3 FLAGSTONE DRIVE

SP# 01-22

STAFF REPORT

Re: Town of Hudson Planning Board Review
3 Flagstone Drive Site Plan, 3 Flagstone Drive
Tax Map 222 Lot 14; Acct. #1350-990
Reference No. 20030249.2120

SHEET TITLE:
SITE LAYOUT PLAN
SHEET NUMBER:
C-301
ORG. DATE - 01/17/2022

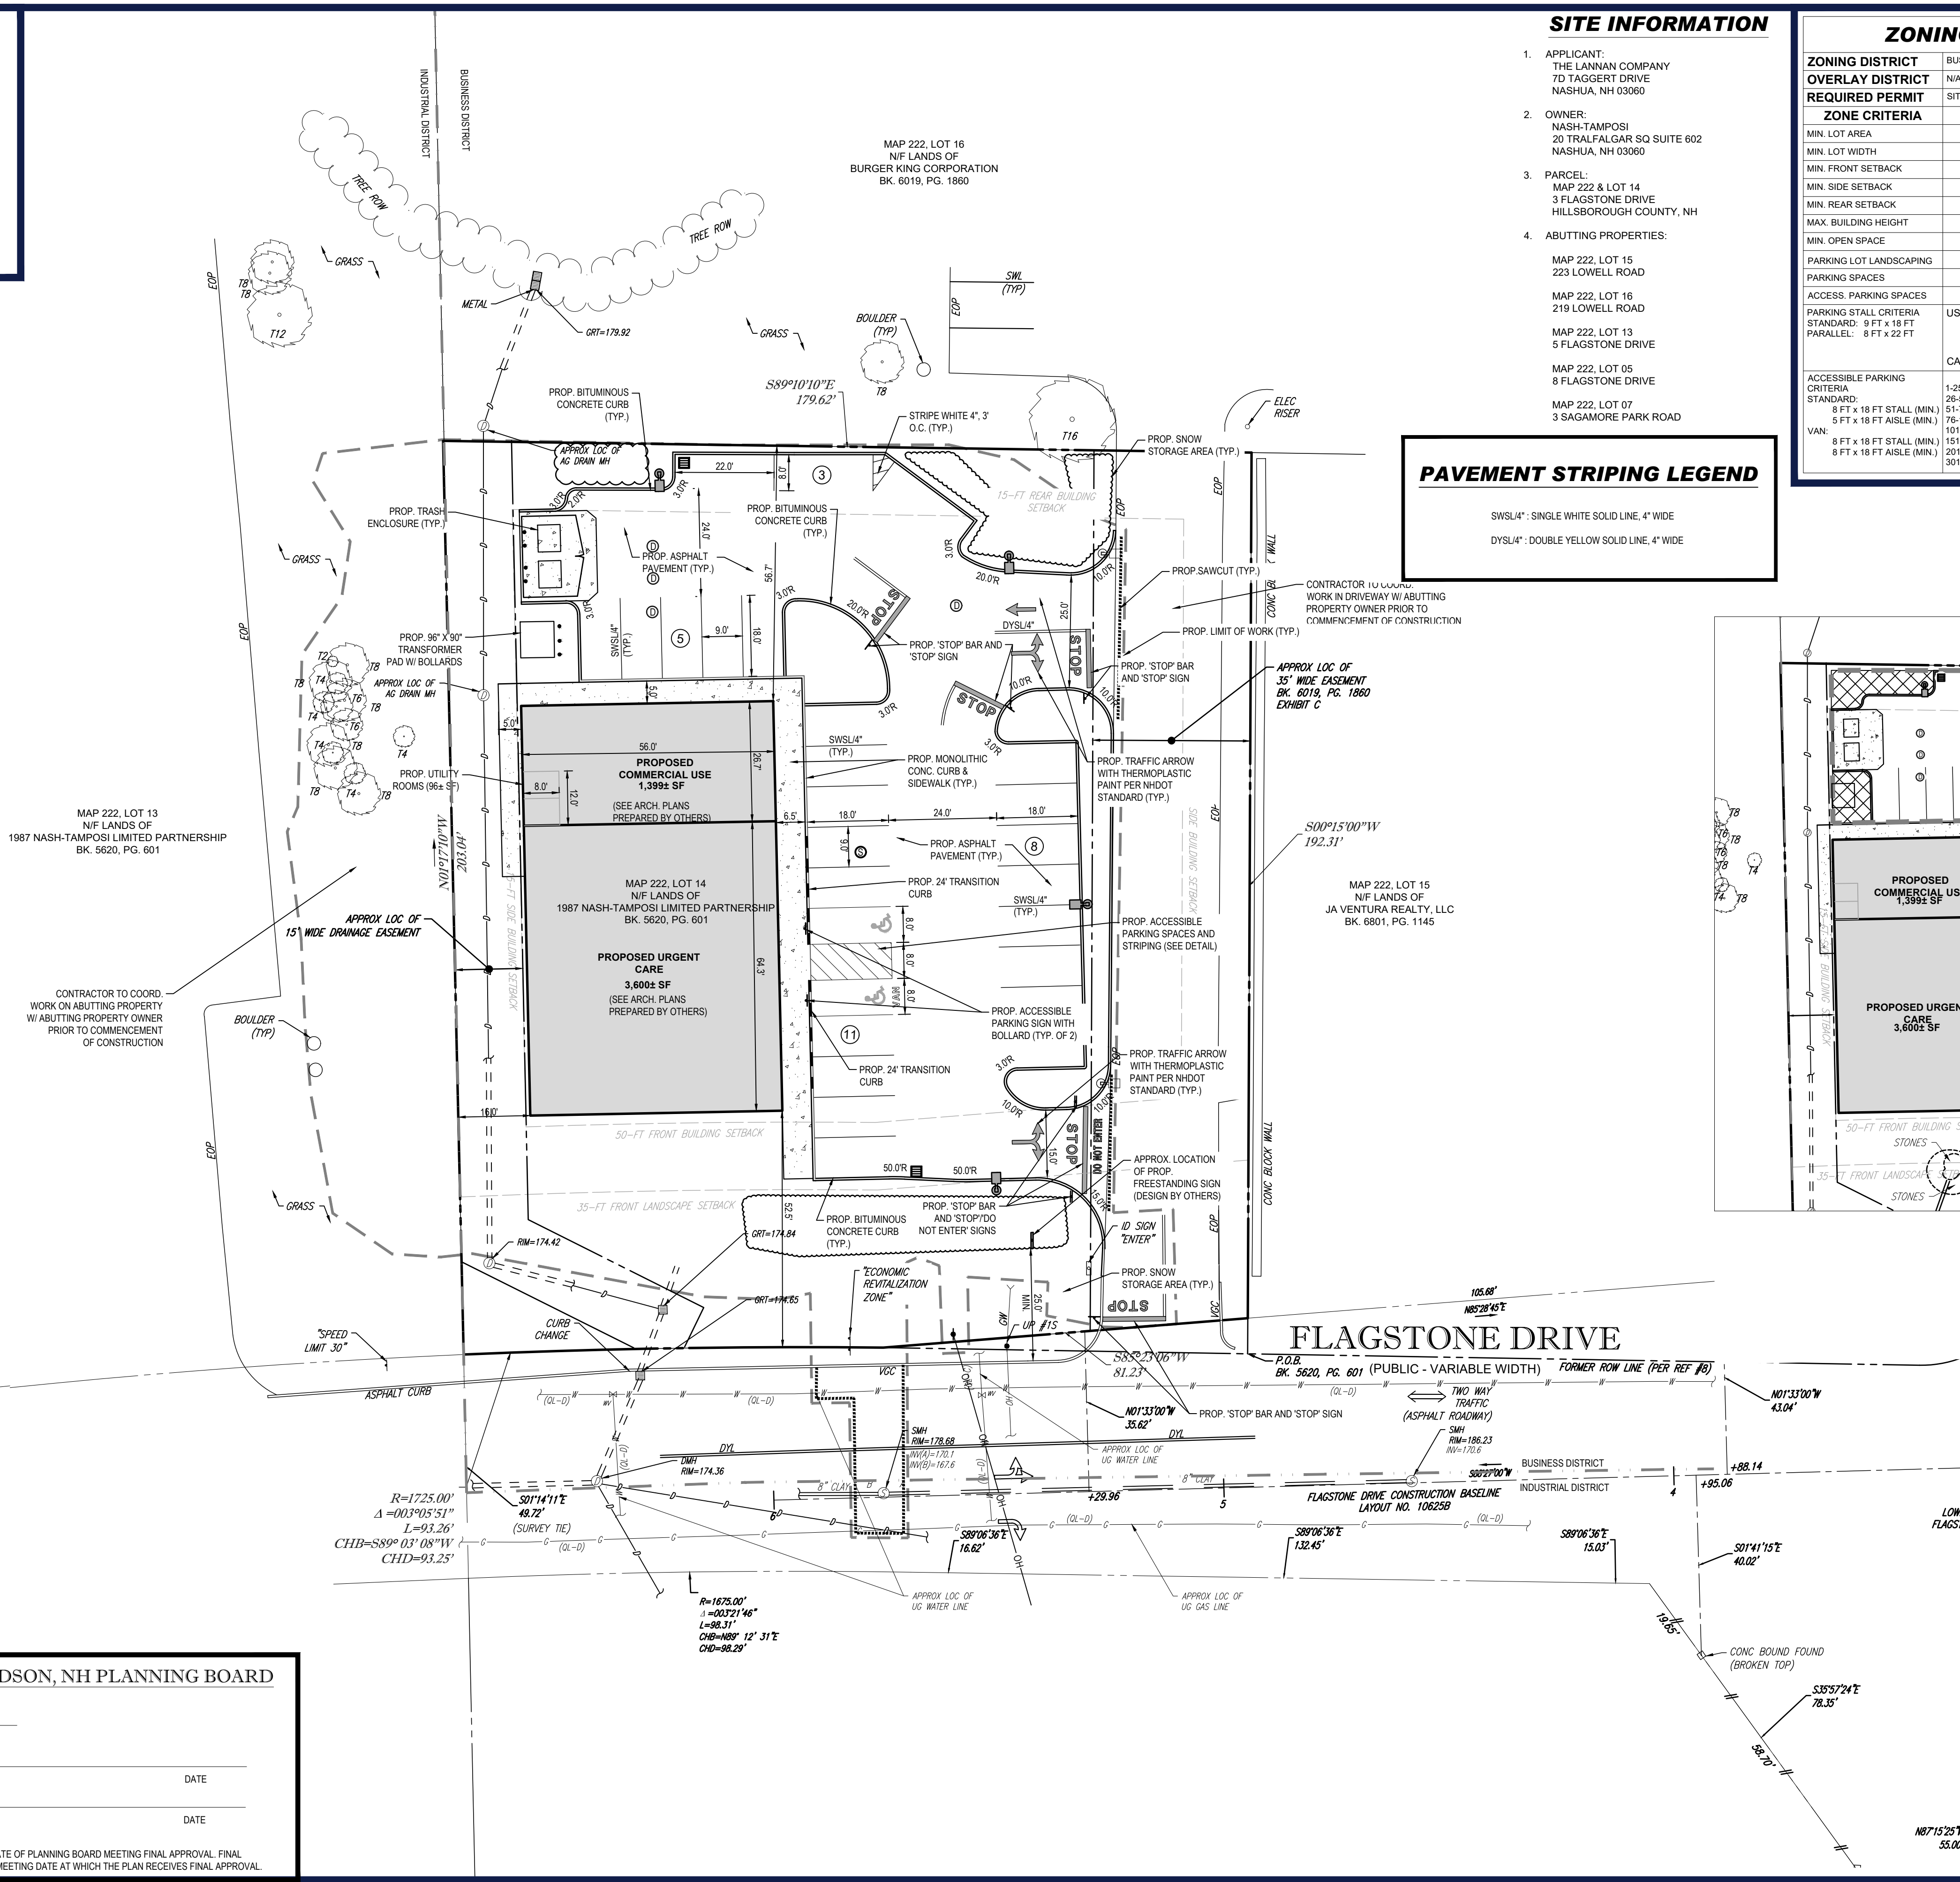
- a. The applicant should review the note numbers on the left of sheet C-102 as they appear to have been cut off.

- b. ETGTD Section 565.1.1. The applicant is reminded of Town of Hudson requirements for the importing of off-site fill materials for use in constructing this project. It is recommended that these requirements be stated on the plans for the Contractors attention.
- c. It appears that the arrow for the snow storage area note should be pointing to the nearby clouded area, not the general lawn area, on sheet C-301.

C-602

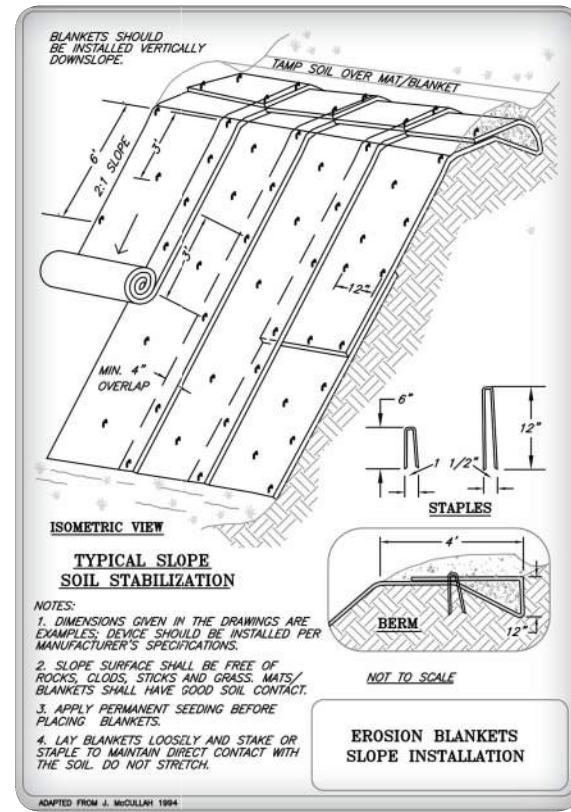
- h. HR 290-5.A.10. The applicant should provide labels for proposed locations of the hay bales, as detailed upon the Plan Sheet C-602.
- i. HR 290-6.A.8. The applicant should note the requirement to coordinate a pre-construction meeting with the Town Engineer.
